HISTORIC LANDMARK COMMISSION
APPLICATION FOR A CERTIFICATE OF APPROPRIATENESS
APRIL 5, 2023
HR-2023-018007
HYDE PARK HISTORIC DISTRICT
3813 AVENUE H

Demolish existing garage and construct a new garage apartment.

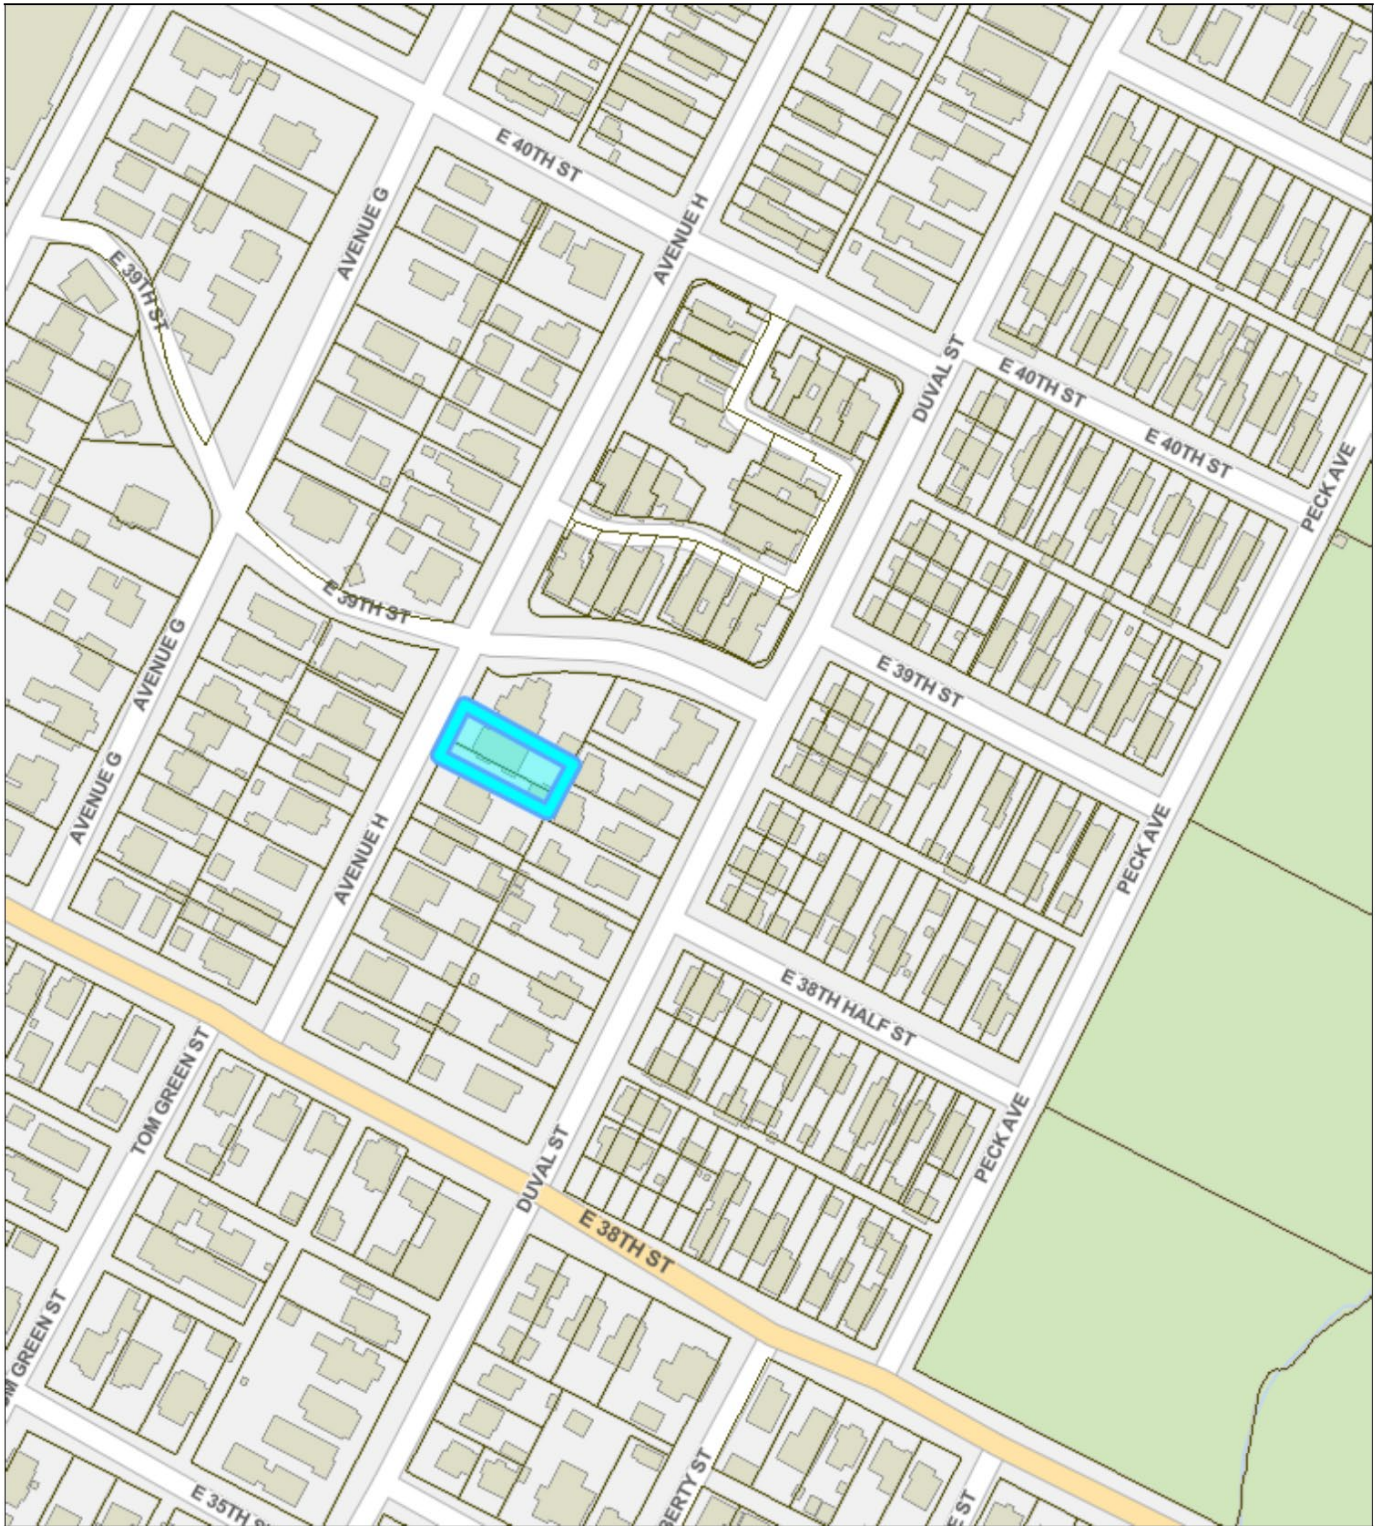
The proposed garage apartment is mostly compatible with the main house; however, the exposed rafter tails are somewhat anachronistic and should not be included in the design.

Request that the applicant omit exposed rafter tails at the front of the new garage apartment, then approve the Certificate of Appropriateness.
